Historic Architectural Review Commission Staff Report for Item 5

Meeting Date: May 24, 2022

Address: #418 United Street

Description of Work:

418 UNITED ST KEY WEST, FL 33040 FRONT ELEVATION

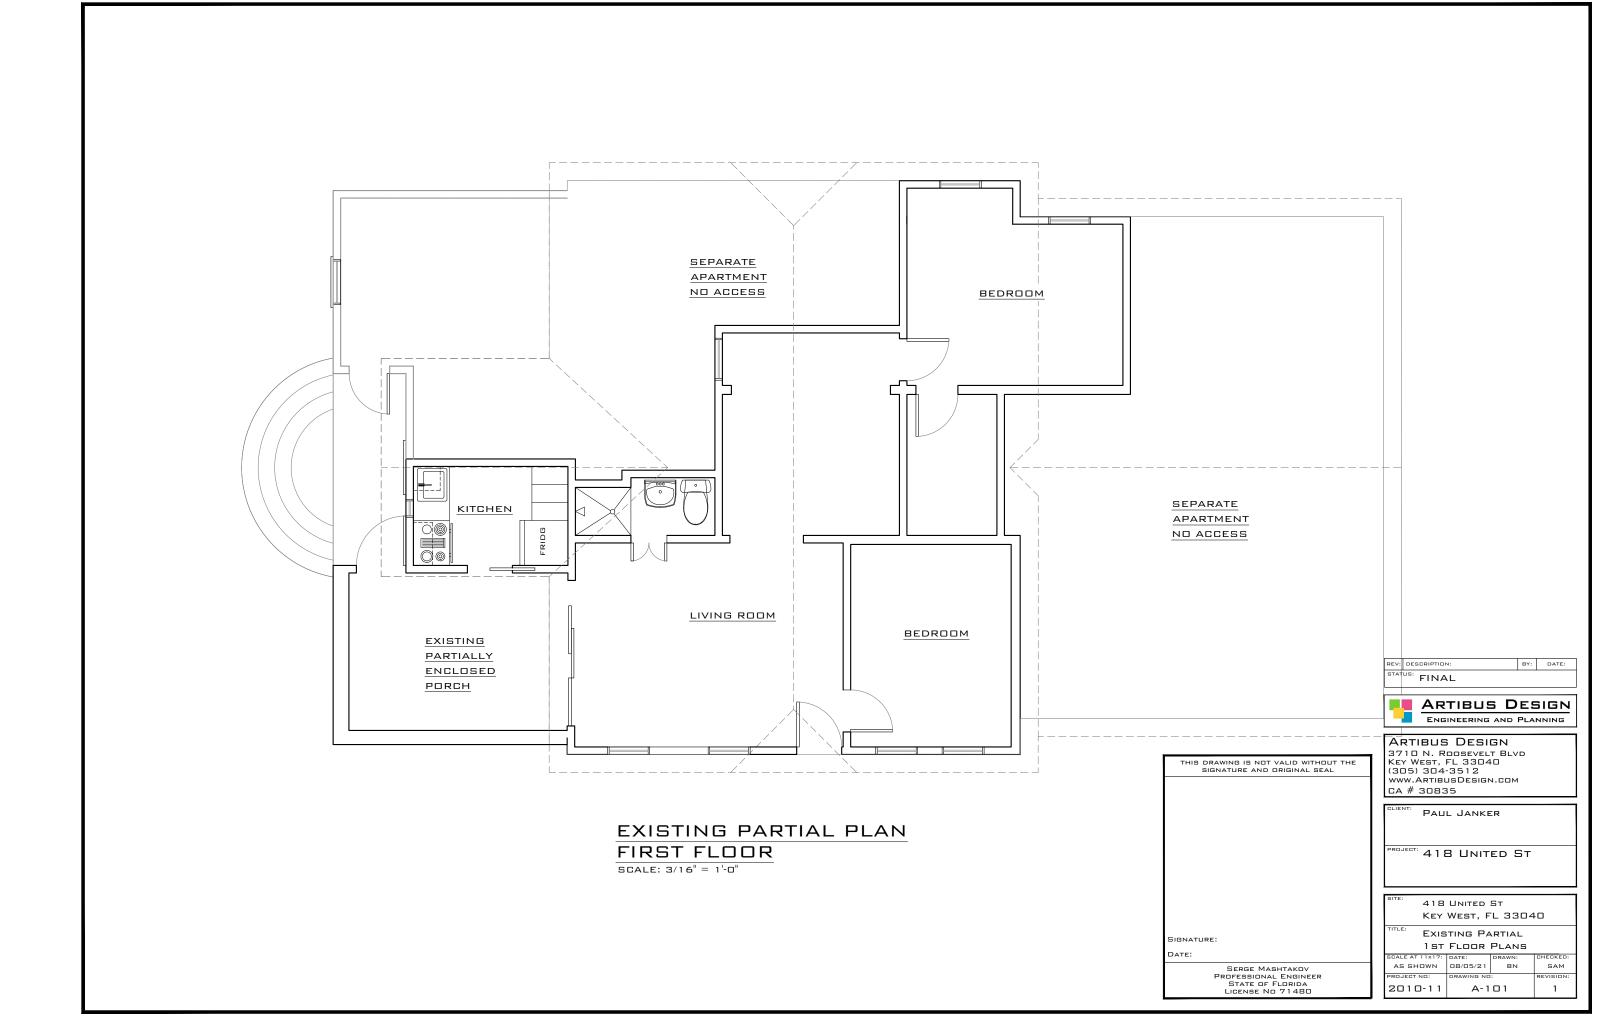
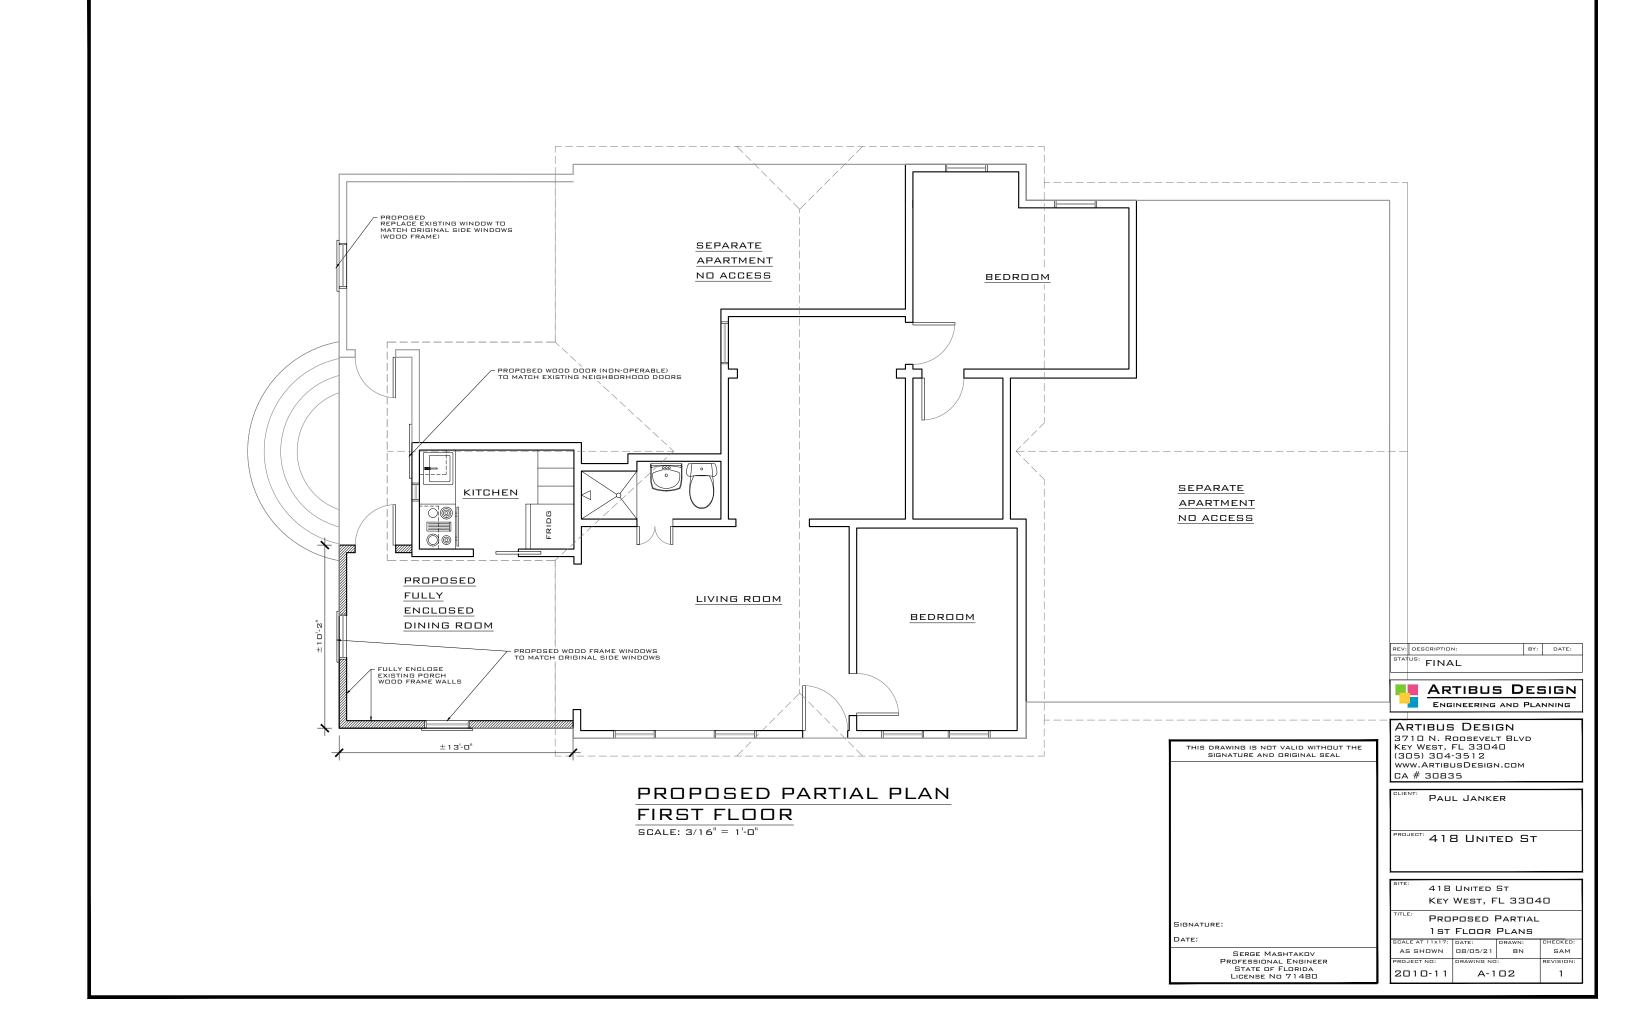
This application also proposes the replacement of two sliding glass doors on the second-floor front porch with new wood frame French doors. A sliding glass door on the side (east) elevation of the second-floor porch is also proposed to be replaced with a small 2-over-2 wood frame window. An existing non-historic 6-over-6 window on the front elevation is also proposed to be replaced with a 2-over-2 wood window to match the historic windows.

The proposal to enclose the first-floor porch on the southeast corner of this historic residence would be creating an addition on the front elevation, which is "prohibited unless factual evidence for the building or structure in question proves the contrary." Even though there is an existing partial enclosure in this location, as well as an existing fully-enclosed portion on the opposite southwest corner, staff was unable to locate any past approvals for these additions.

In terms of the proposals for the new windows and doors, staff sees no conflict with the guidelines, and the new units proposed are more appropriate than the existing.

418 UNITED ST KEY WEST, FL 33040 SIDE ELEVATION

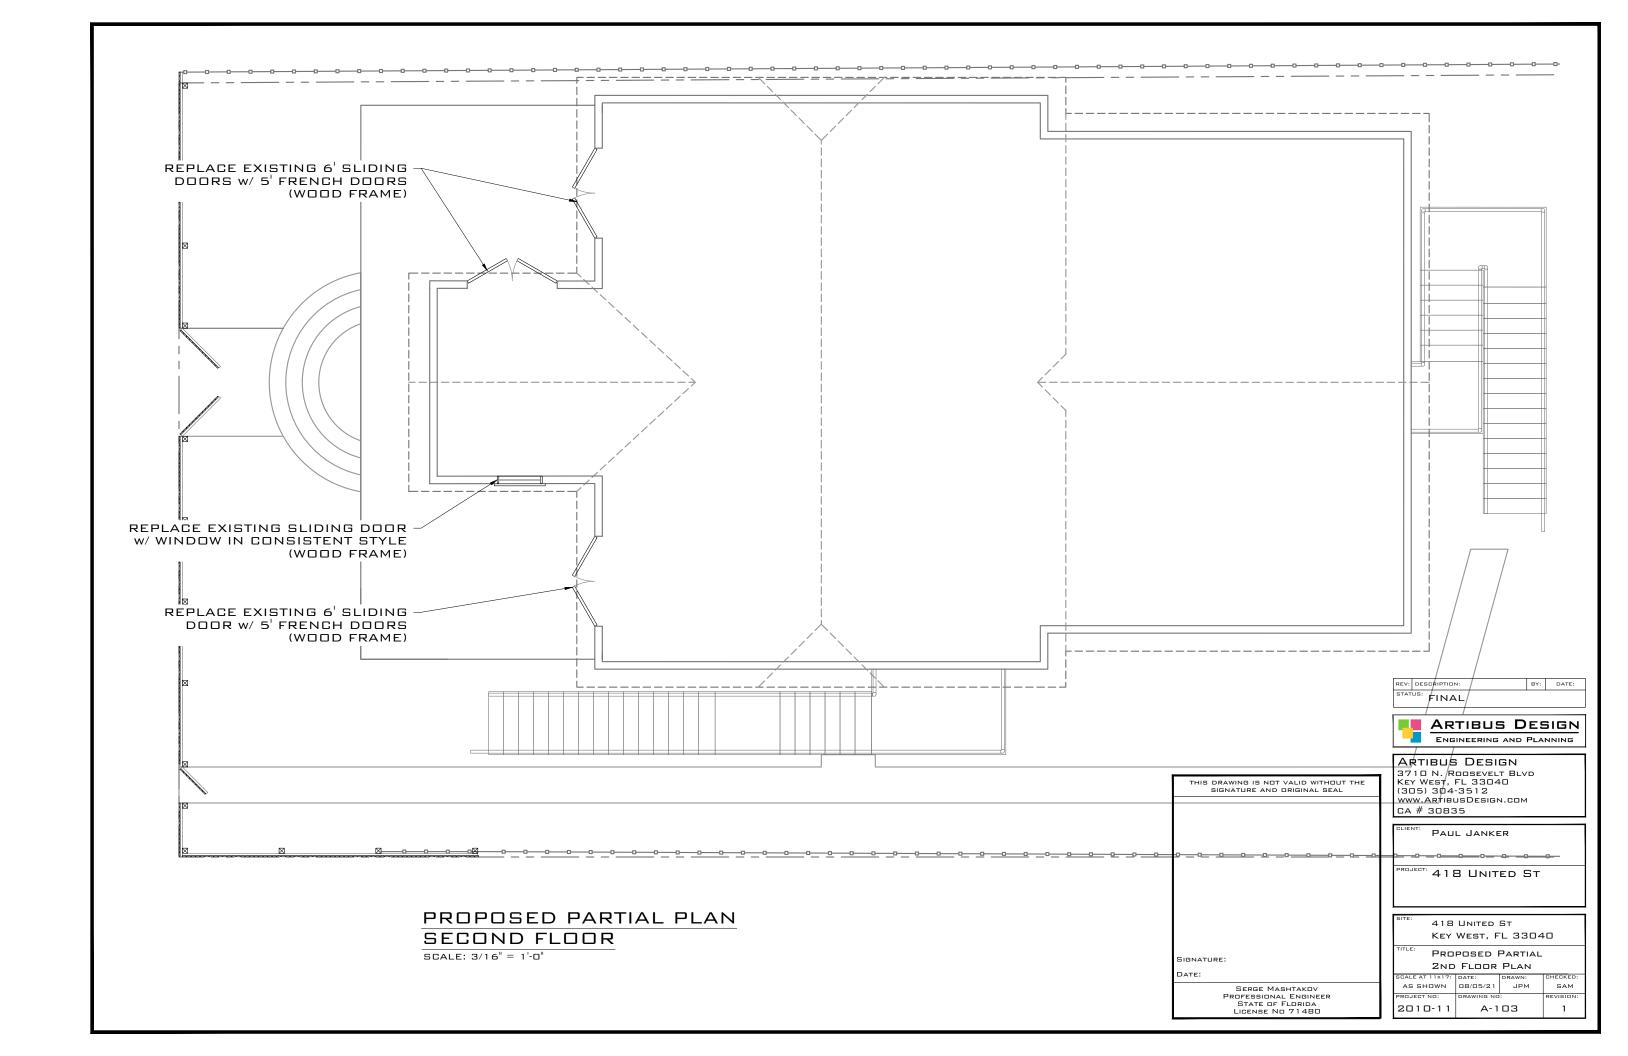
would be installed on the front elevation of the new enclosure, and one 2-over-2 wood window would be installed on the side elevation of the new enclosure—the design of the windows would be made to match existing historic windows on the side elevation.
